BOARD OF APPEALS, CITY & COUNTY OF SAN FRANCISCO

Appeal of	Appeal No. 25-025
SUSAN SUGER and TOM SUGER,)	
Appellant(s)	
vs.)	
DEPARTMENT OF BUILDING INSPECTION,	
PLANNING DEPARTMENT APPROVAL Respondent

PRELIMINARY STATEMENT FOR APPEAL NO. 25-025

STATEMENT OF APPEAL FOR PERMIT 202505297531

Please see exhibits on the following pages.

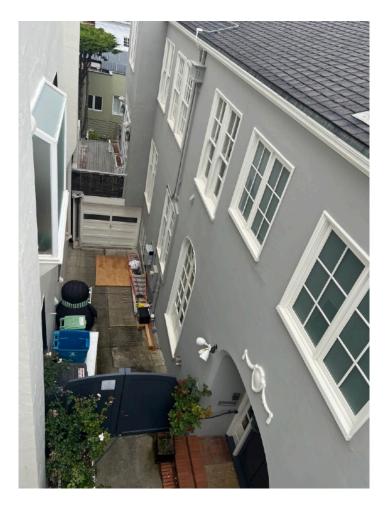
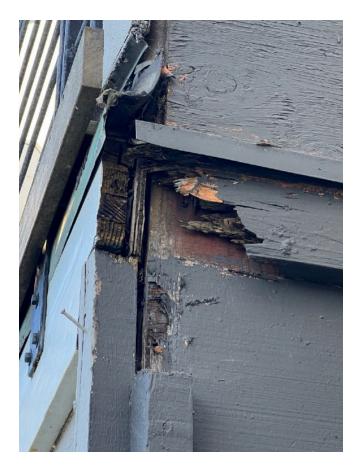
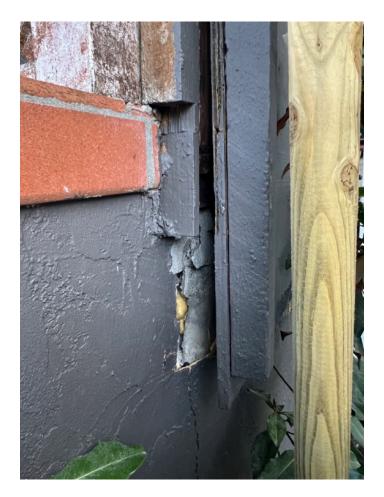
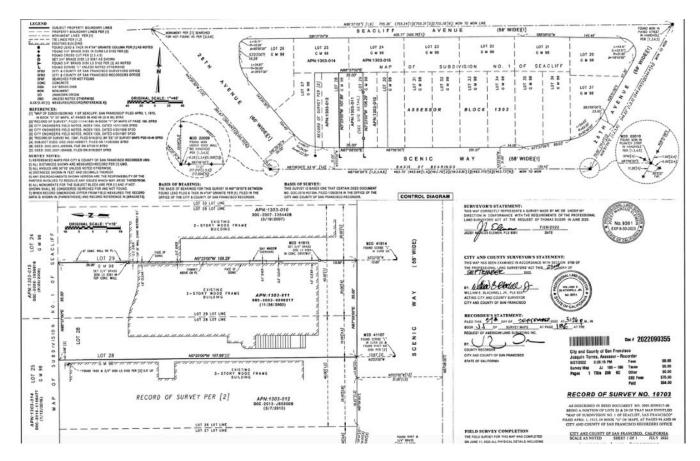
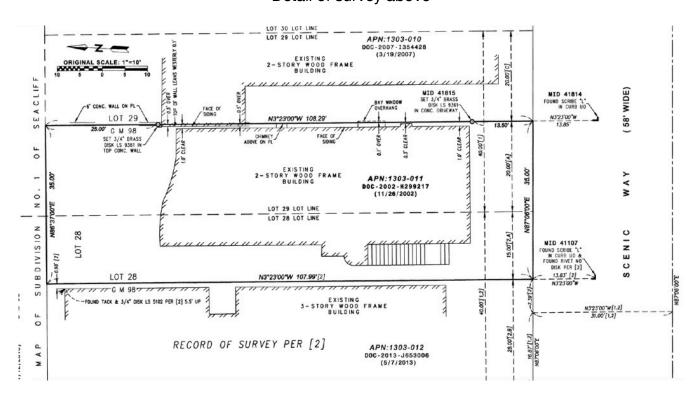
In addition to the sheathing being non fire rated, we believe the damage to the west wall of the garage/laundry room at 50 Scenic Way to be much more extensive than the siding

detaching from the building and the framing being rotten at the northwest corner. The wall leans precariously to the west - between the foundation of 50 Scenic Way and the east wall of our house there is a 7 inch gap, above the foundation at the base of the sheathing of the garage/laundry room and the east wall of our house there is a 5-5/16 inch gap, and at the top of the wall of the deck there is only a half inch gap. Soon this wall will rest against our home and we are very concerned about the significant fire hazard. We were told by a contractor, who was asked by the property owners to evaluate the wall, that it was rotten and needed to be replaced. If some wall-related repairs from the interior of that space have been made, I have found no permits at the records department of SFDBI. We have, however, noticed some strange foam-like extrusions that have recently leaked through the wall and onto our property. We also must mention that the base of the compromised wall of this structure extends over our property line. This encroachment has caused our home to have a blind wall that we have been unable to protect with stucco congruent with the rest of the body of our house. The encroachment is detailed in the property survey for 56 Scenic Way and is recorded with the city.

It is our hope that the Board of Appeals amends permit #202505297531 to make required repairs to all the affected components of the NOV, that all work be done in compliance with all current San Francisco Building Codes and that the garage/laundry room be pushed back behind the property line.

We are in agreement with the Appellant's request that DBI Permit No. 2025-0529-7531 should be revised to include repairing the damaged garage level wall below the deck (see Figure 1a and 1b). This area was unintentionally omitted when we conducted our initial site visit and later corrected once we understood the entirety of the scope of item #2 of the NOV #202536052.

We agree with the appellant's assertion that part of the damaged wall was not addressed within the scope of work of the originally issued permit drawings and have already prepared revision permit drawings to include this additional scope. Therefore, we respectfully request that permit 2025-0529-7531 be reinstated, with no new conditions, so that the permit revision documents can be submitted to fully address the Notice of Violation #202536052.

Preliminary copy of proposed revision permit drawings (see next page).

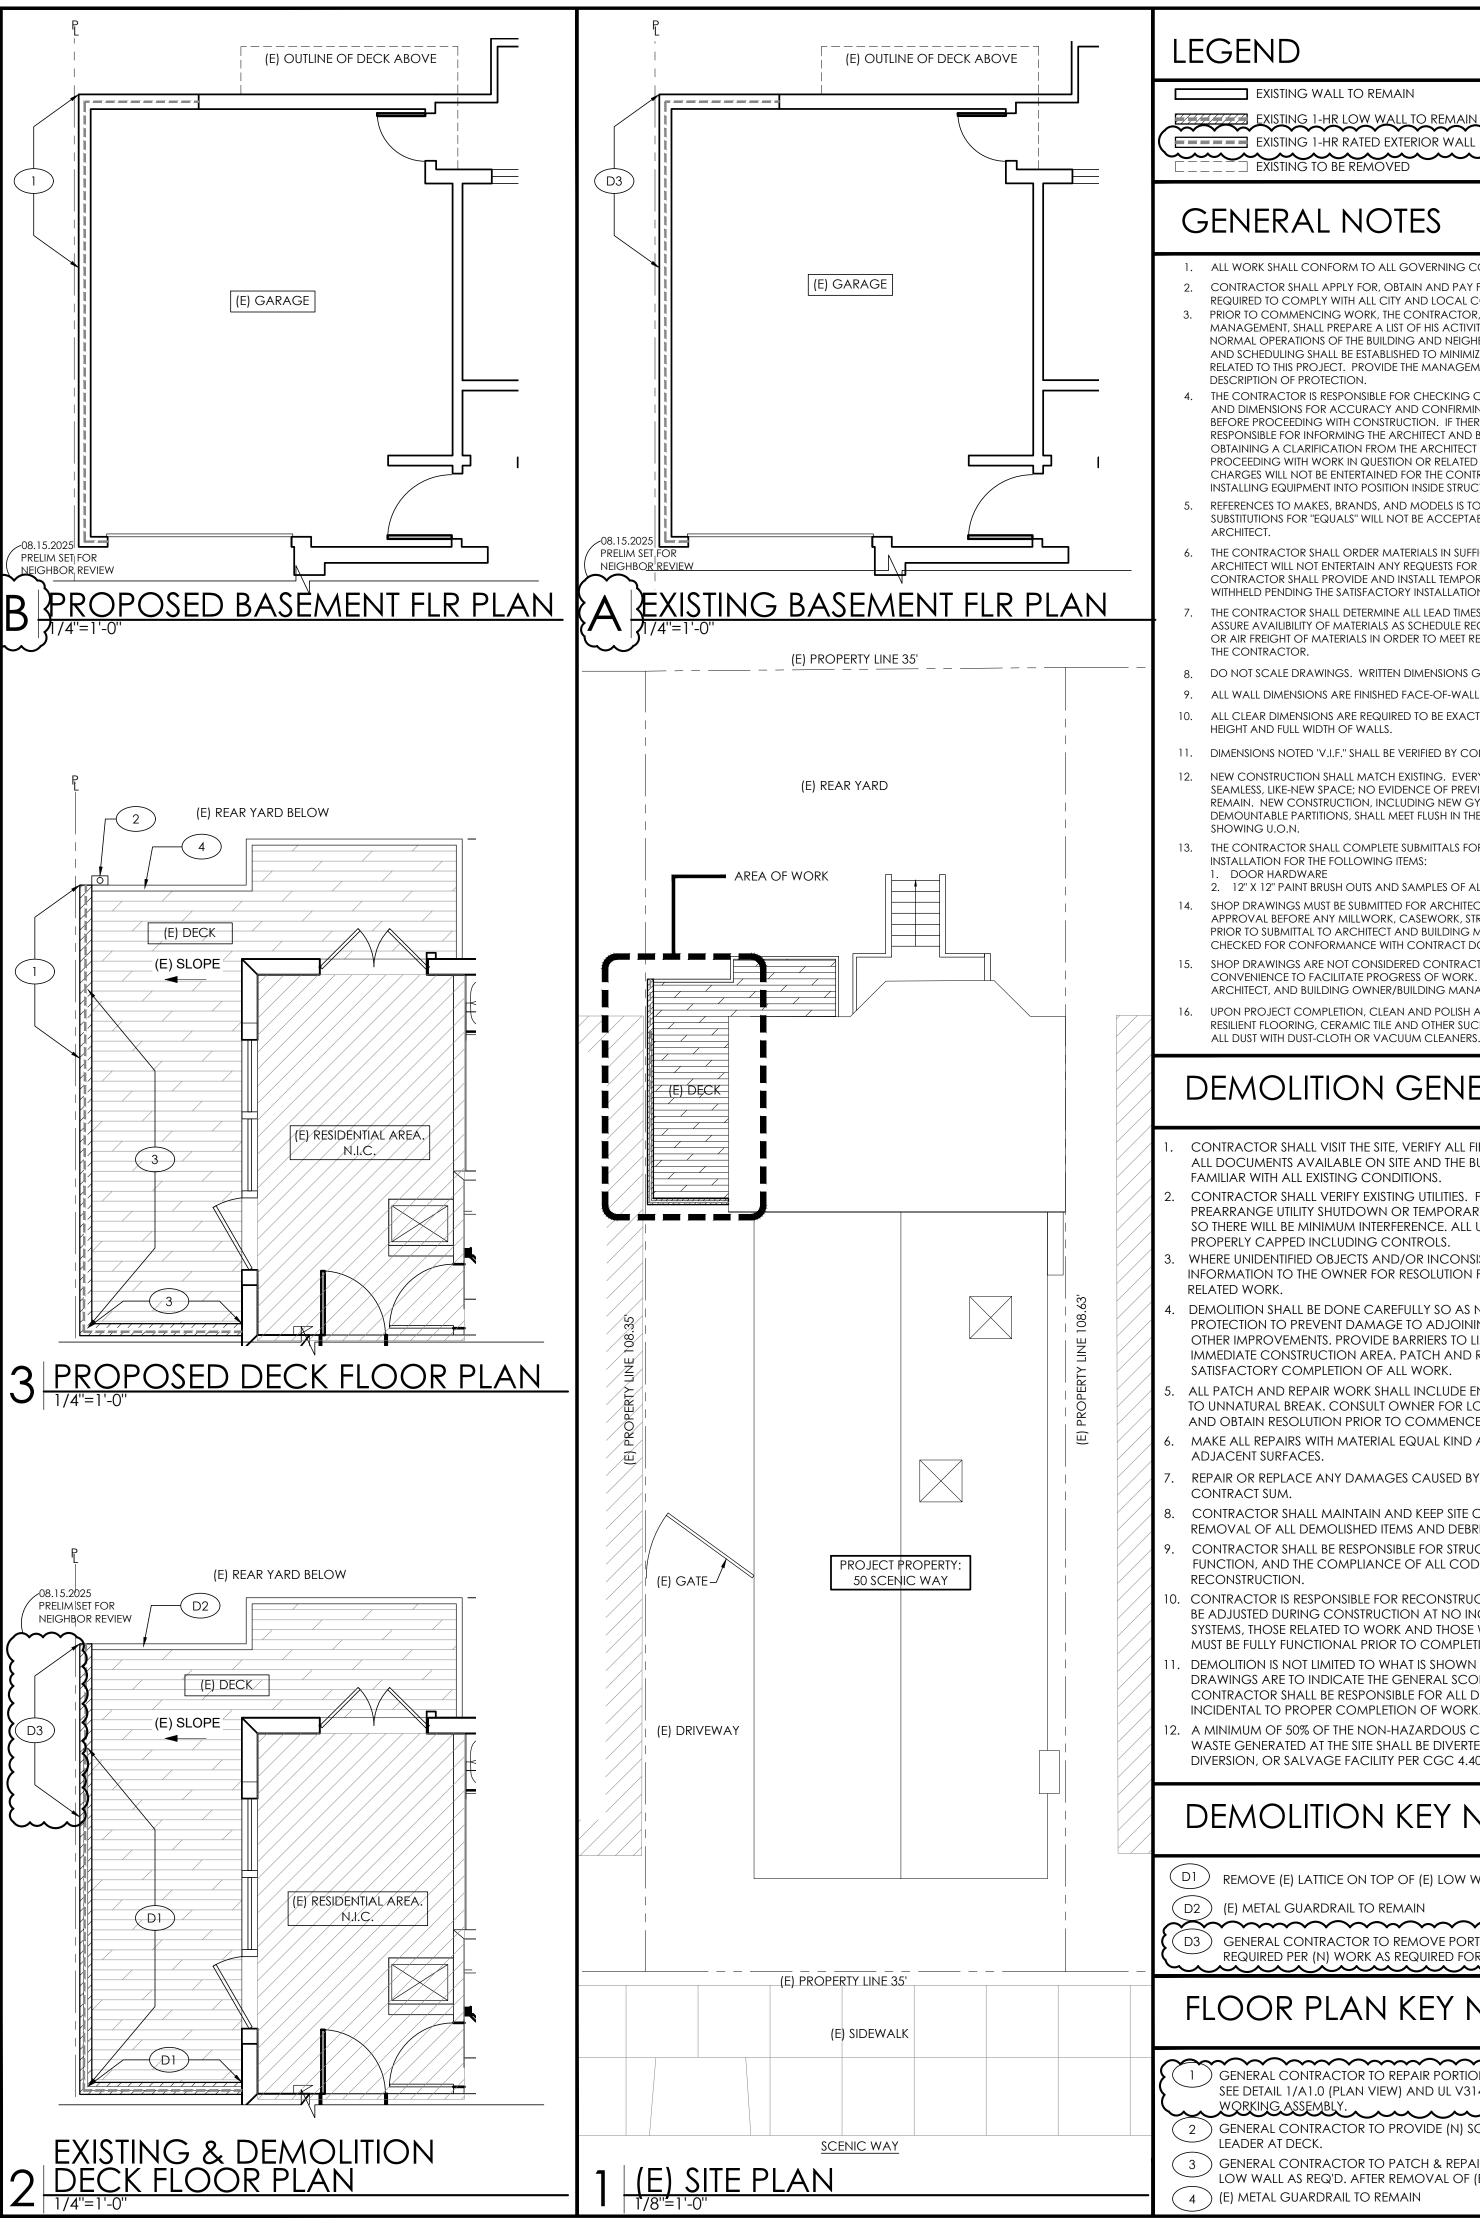
D-Scheme Studio then coordinated with Tom and Susan Suger and scheduled a follow-up site visit for 7/28/25, in order to view the portion of damaged wall originally missed in the previous site visit and to prepare revised permit drawings adding this to the scope of work. The revised permit drawings were prepared and a Preliminary Copy sent to Tom and Susan Suger, for their review on 08/15/25. Refer to Exhibit C.

- GENERAL CONTRACTOR TO REPAIR PORTION OF (E) EXTERIOR WALL. SEE DETAIL 1/A1.0 (PLAN VIEW) AND UL V314/A1.0 (SECTION) FOR A COMPLETE
- WORKING ASSEMBLY. GENERAL CONTRACTOR TO PROVIDE (N) SCUPPER AND (N) RAIN WATER LEADER AT DECK.
- GENERAL CONTRACTOR TO PATCH & REPAIR (E) CEMENT PLASTER FINISH AT (E) LOW WALL AS REQ'D. AFTER REMOVAL OF (E) WD. LATTICE. 4) (E) METAL GUARDRAIL TO REMAIN

- REPAIR SELECT PORTION OF (E) NORTHWEST CORNER WALL ALONG DECK AND BASEMENT FLOOR. REMOVE TEL NON-FIRE RATED LATTICE ADJACENT ON TOP OF LOW EXTERIOR DECK
